ADDENDUM NO. 2

Rochester City School District

Dr. Walter Cooper, School #10

February 28th, 2018

274 North Goodman Street
Rochester, New York 14607
P. 585.271.0040
EDR Project No. 17096

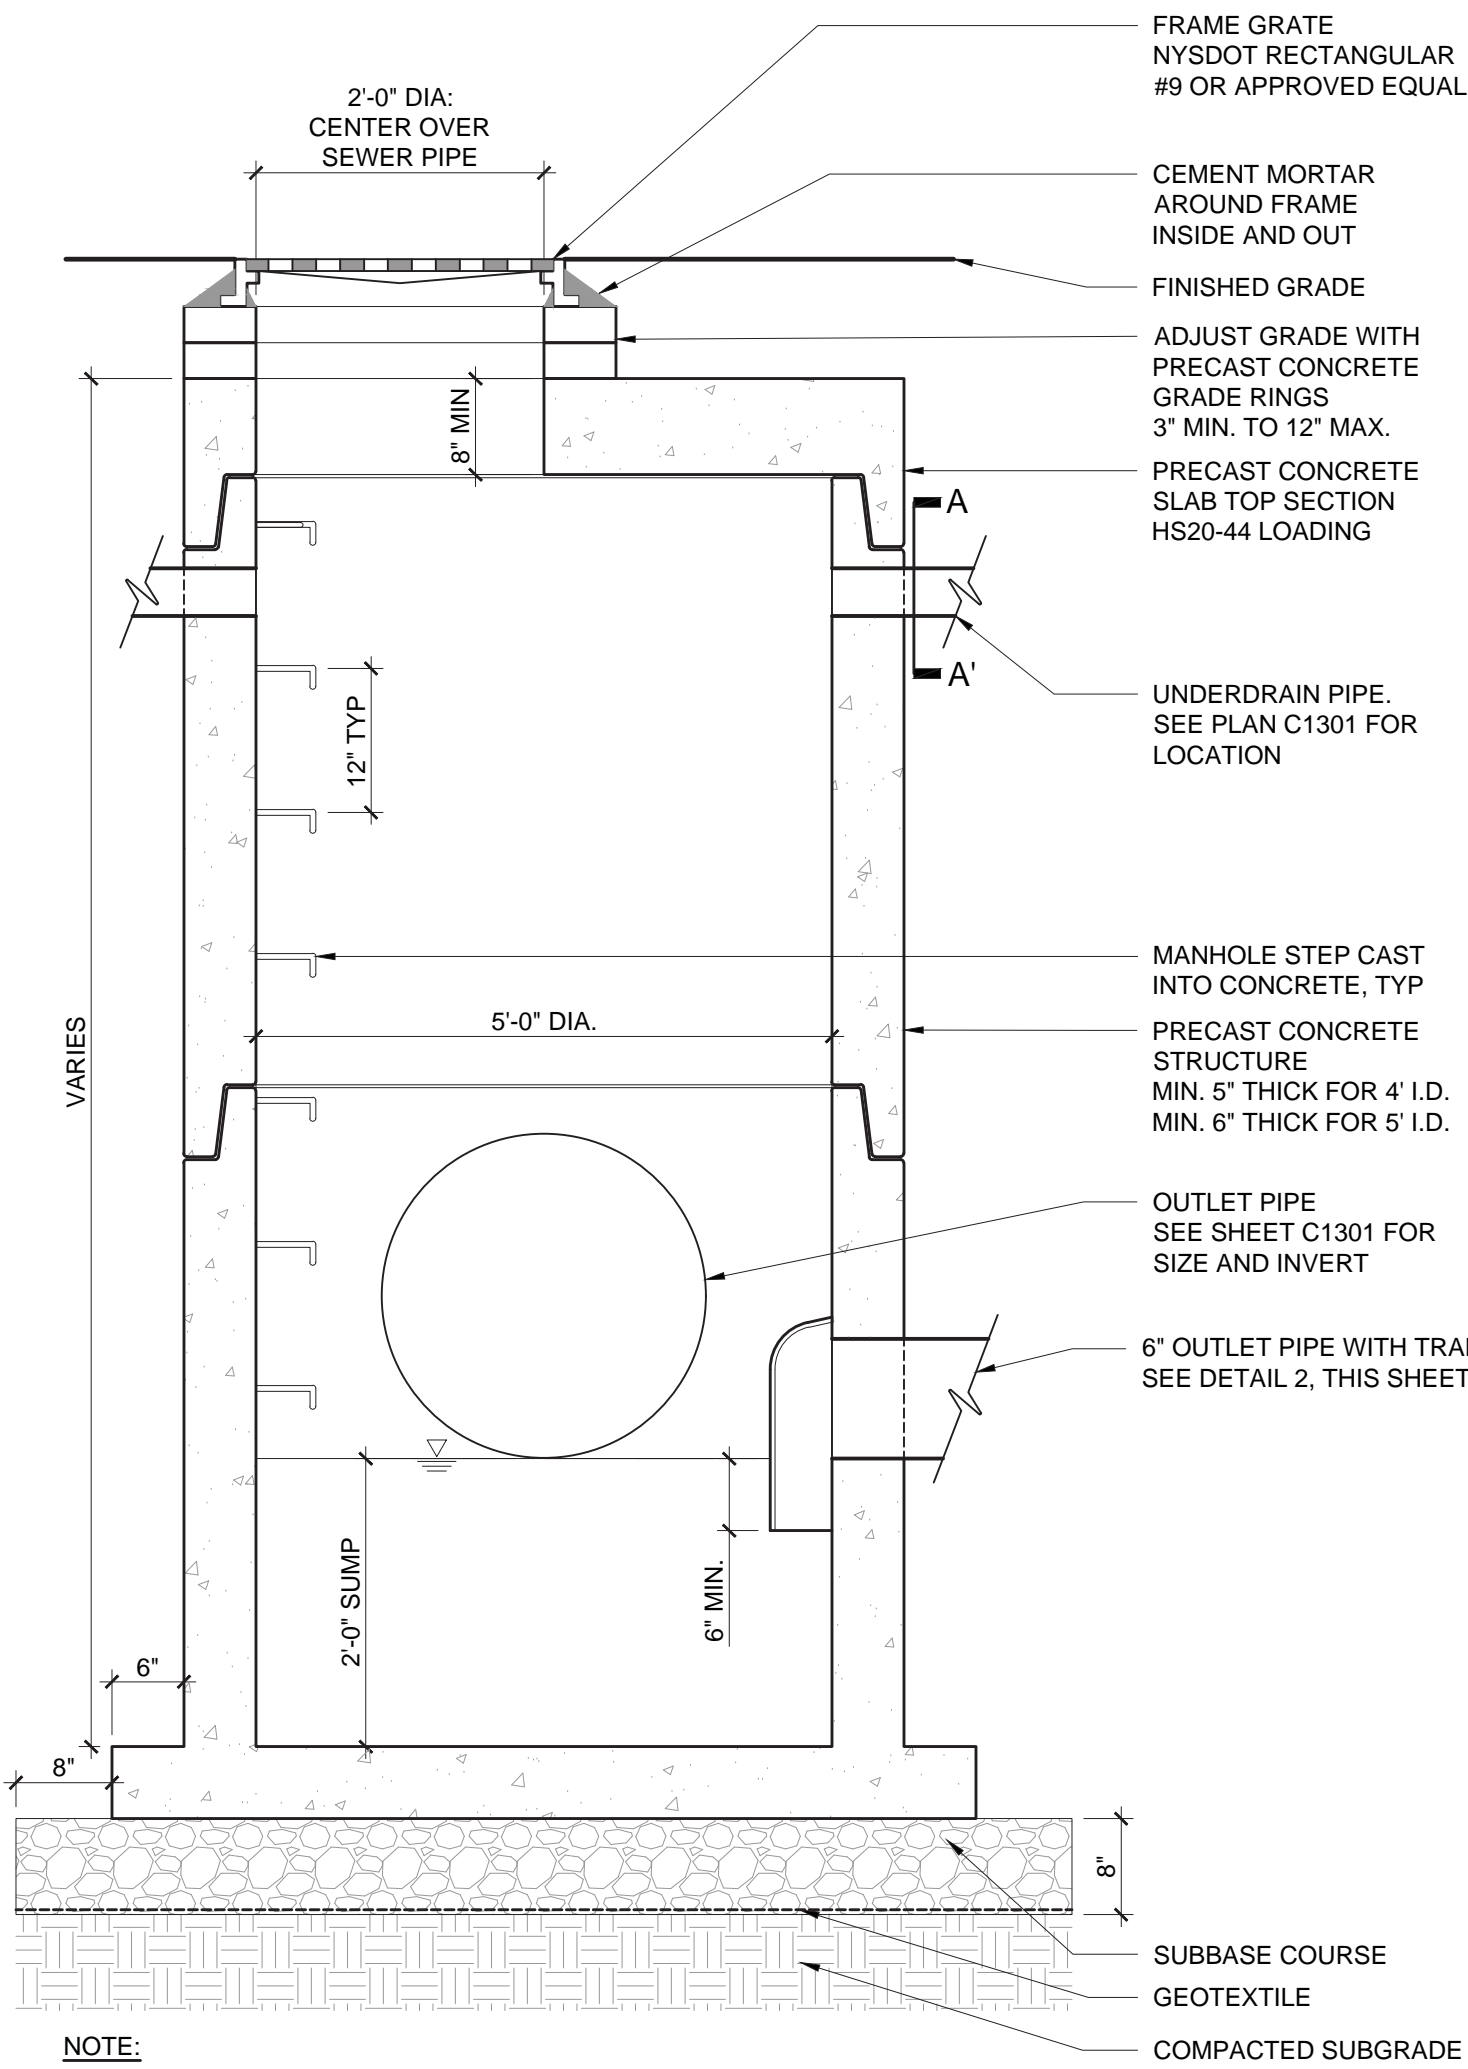
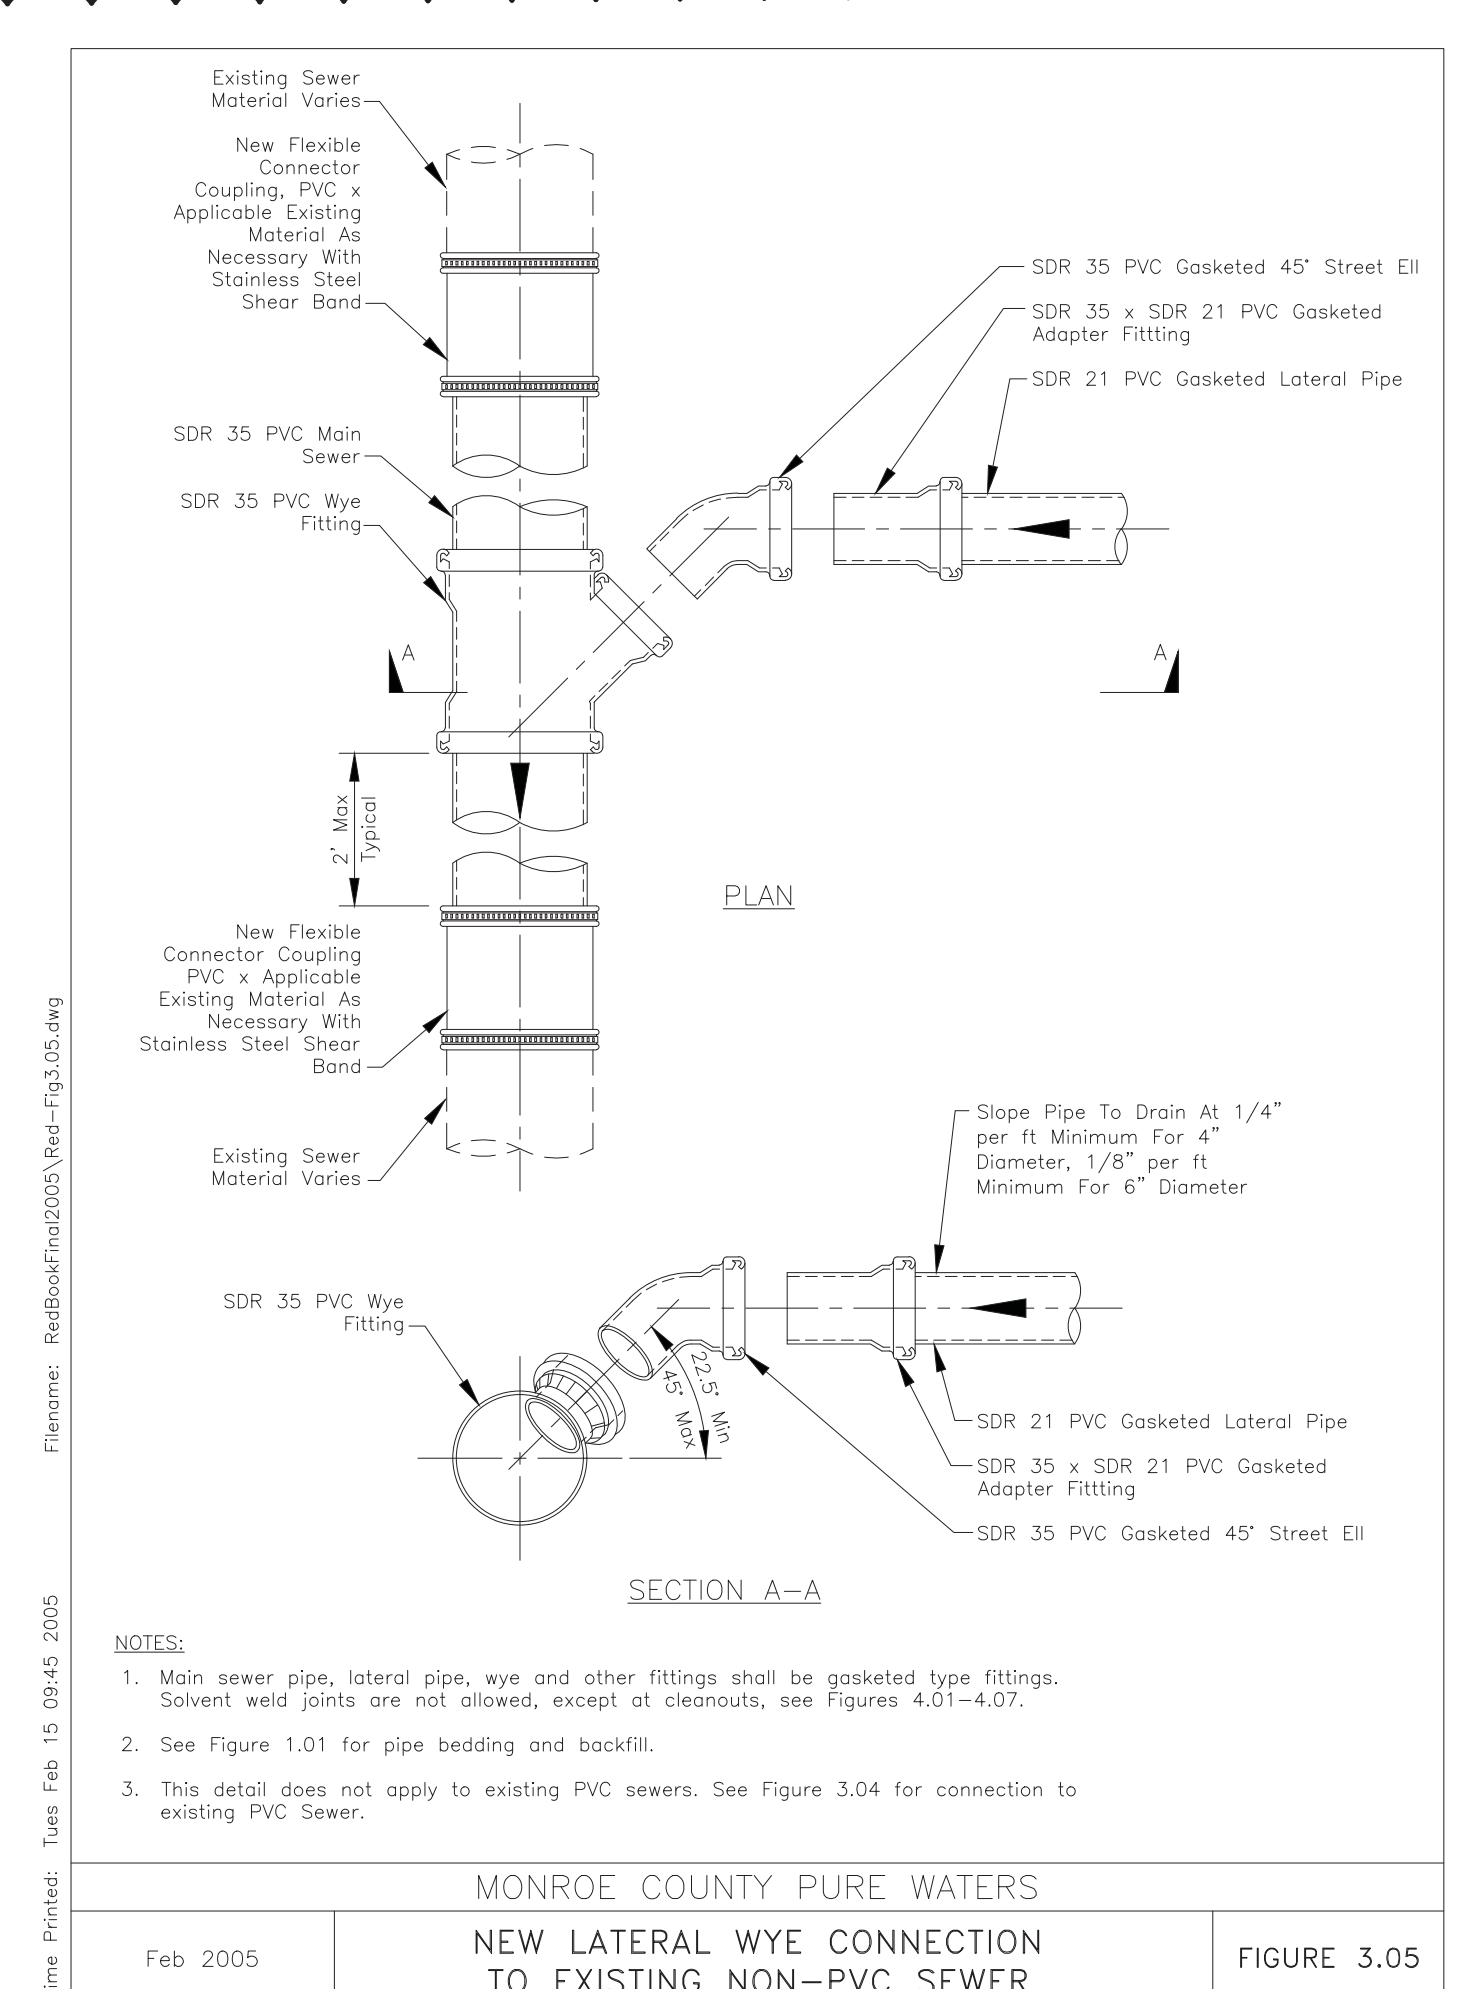
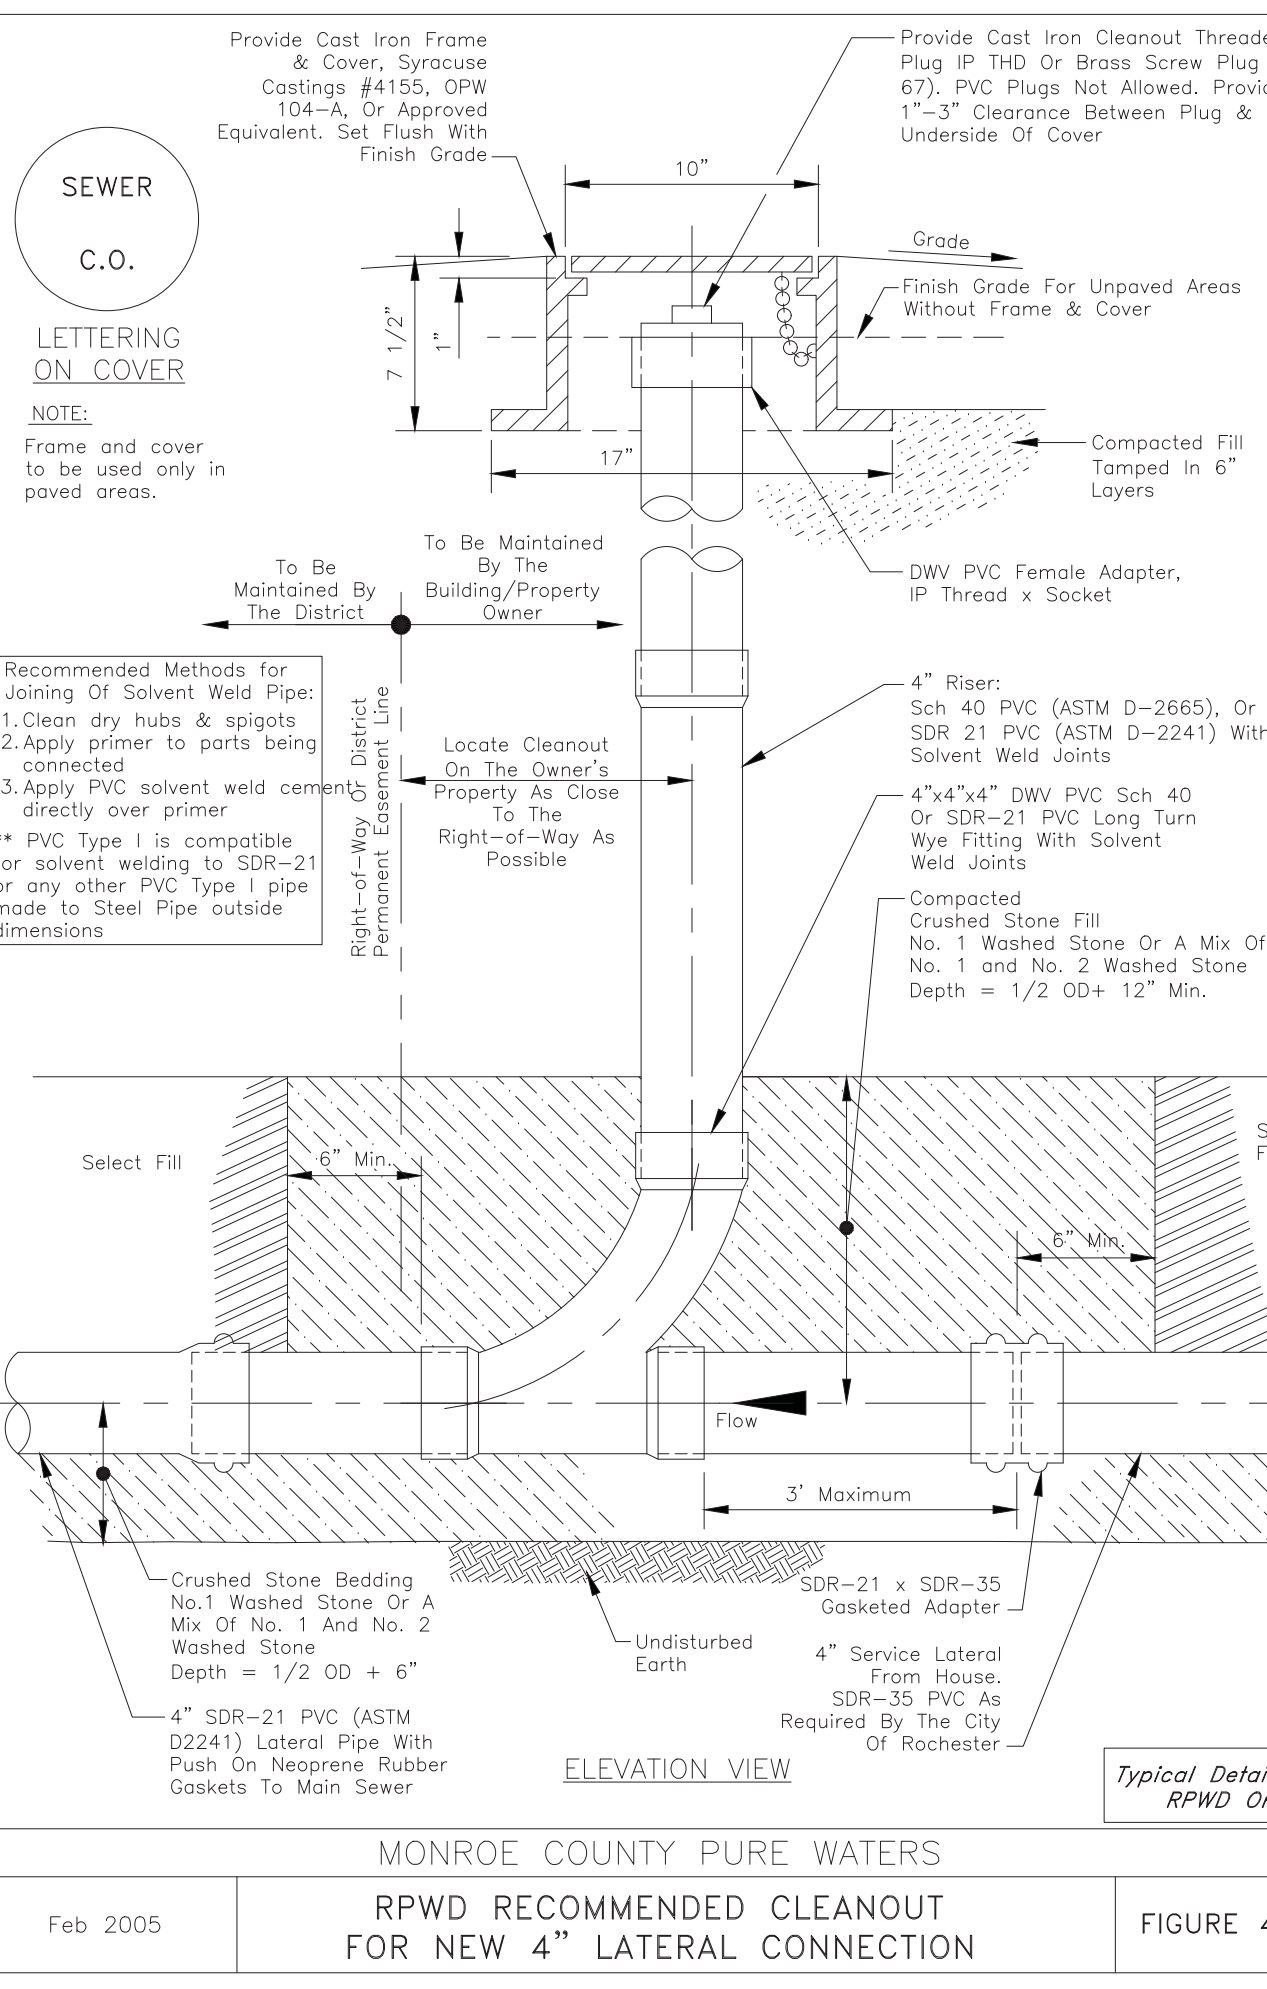
Item AD2-15 **REPLACE** drawing in its entirety with attached “C1607 – DETAILS.” Add Monroe County Pure Waters required details.
